Address	Form Title	Form Number	
	[REDACTED] Rogers, [REDACTED] [REDACTED]	Daily Structural Steel Inspection Report	NSTC.NDT.VTP.01.F1	
			Revision 0	Date: 06/18/26

Description of items inspected
Structural Steel: Anchor Bolting, Level 02 Framing and Brace Frames
Location of items inspected
Grid Lines (01 to 27/A to M)

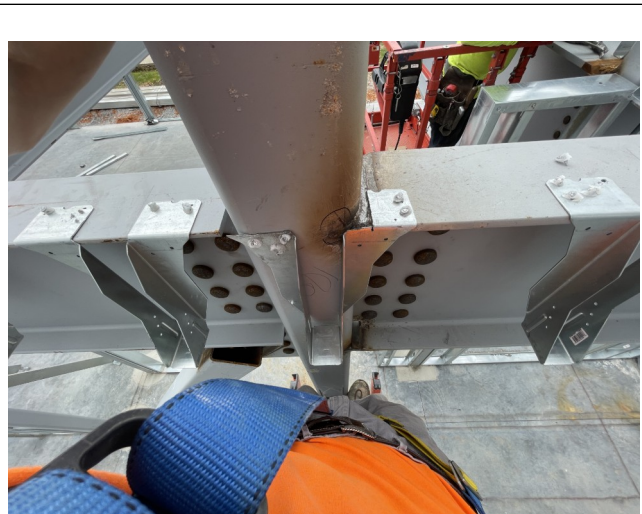
Moment connections at (4.7/E) and (4/H.8) were repaired and appeared visually acceptable; however, the remaining discrepancies listed below were observed. Several of these connections contained previously documented discrepancies, including gapped backing bars. The repair process was not observed, and adequate root weld penetration could not be verified.
